ECE/TRANS/WP.29/2009/104
23 July 2009

Proposal for the 03 series of amendments to Regulation No. 107
(M₂ and M₃ vehicles)

Submitted by the Working Party on General Safety Provisions */

Model A

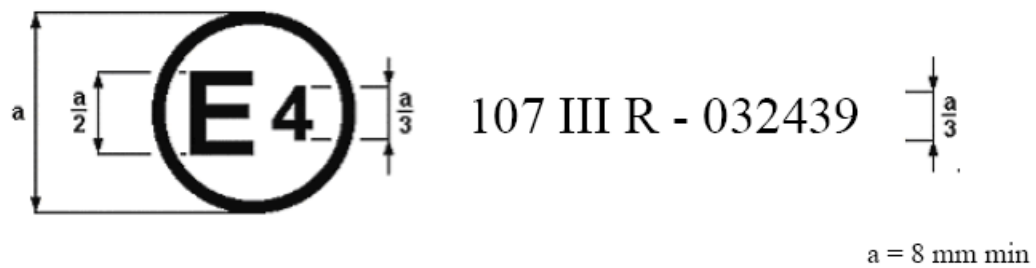
The above approval mark affixed to a vehicle shows that the vehicle type concerned has, with regard to its constructional features, been approved in the Netherlands (E 4) for Class III, pursuant to Regulation No. 107 under approval number 032439. The approval number indicates that the approval was granted according to the requirements of Regulation No. 107 as amended by the 03 series of amendments.

Model B

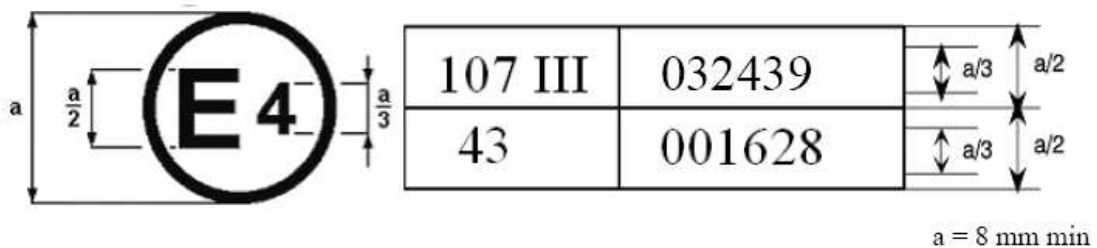
The above approval mark affixed to a vehicle shows that the vehicle type concerned has been approved in the Netherlands (E 4) pursuant to Regulations Nos. 107 and 43.* / The first two digits of the approval numbers indicate that, on the dates on which these approvals were granted Regulation No. 107 included the 03 series of amendments and Regulation No. 43 was in its original form.
